Detailed Site Plan Conceptual Site Plan Stephen's Crossing at Brandywine

DSP-20050-02
CSP-09003

STAFF REPORT

SUBJECT: Conceptual Site Plan Amendment CSP-09003
Detailed Site Plan DSP-20050-02
Type 2 Tree Conservation Plan TCP2-008-2017-02
Stephen's Crossing

Figure 1: Detailed Site Plan

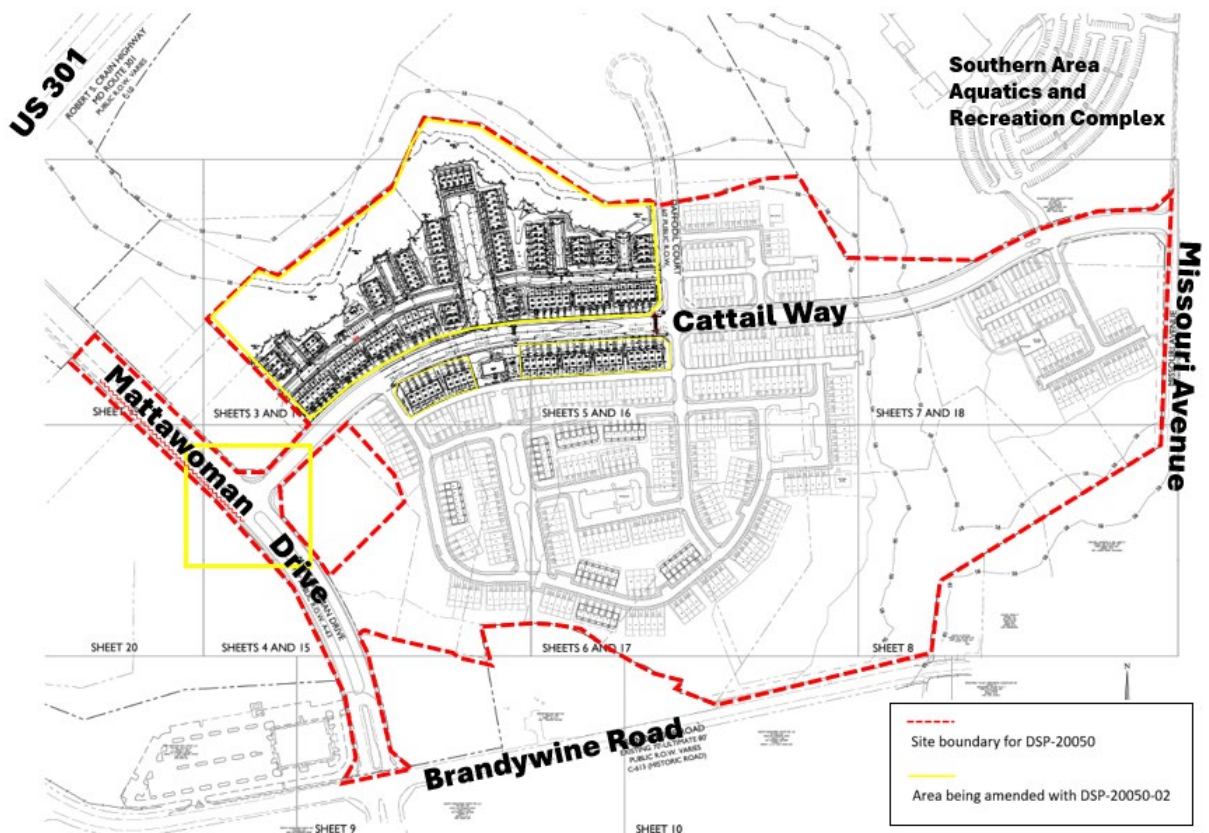
6. **Design Features:** Cattail Way bisects the subject property in an east-west direction and provides connection to the east to Missouri Avenue and to the west to Mattawoman Drive, which leads to MD 381 and US 301 (Robert Crain Highway), located to the south and north of the subject site, respectively. The limits and layout of Cattail Way and Mattawoman Drive, as well as the overall site layout of the residential portion of the Stephen's Crossing mixed-use development, have been approved with DSP-20050. The subject DSP does not revise the overall site layout approved under DSP-20050. Instead, it plans to convert the 116 approved, two-over-two units to townhouse units, and revise the approved eight townhouse lots along Beane Court (Lots 7-14, Block B), for a total of an additional 67 townhouse units to the entire development. These proposed 67 townhouse units are specifically located in Blocks B, C, D, E, J and O. In addition, the subject DSP proposes to construct a roundabout at the intersection of Cattail Way and Mattawoman Drive.
